**R66 SERVICE LETTER SL-03A**

**DATE:** 07 September 2011      **REV A:** 30 September 2011

**SUBJECT:** Clutch Assembly Retaining Bolt Replacement

**FIGURE 1**

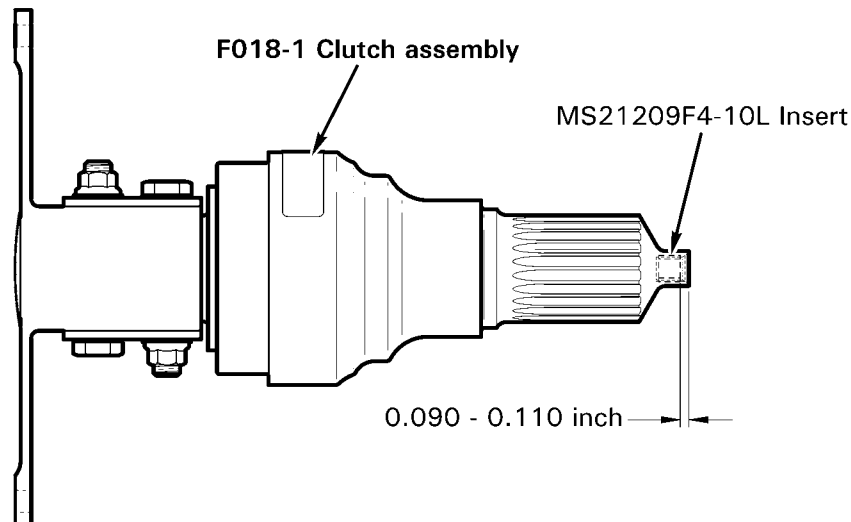
1. At next clutch removal: Remove F018-1 clutch assembly per R66 Maintenance Manual (MM) § 63-12. Discard NAS6604-57 bolt.
2. Refer to Figure 1. Verify end of thread insert is 0.090 - 0.110 inch inboard from tip of splined end of clutch housing; contact RHC Technical Support if thread insert position is incorrect.
3. Install clutch assembly per MM § 63-12, but install (shorter) NAS6604-56 bolt in step 2.
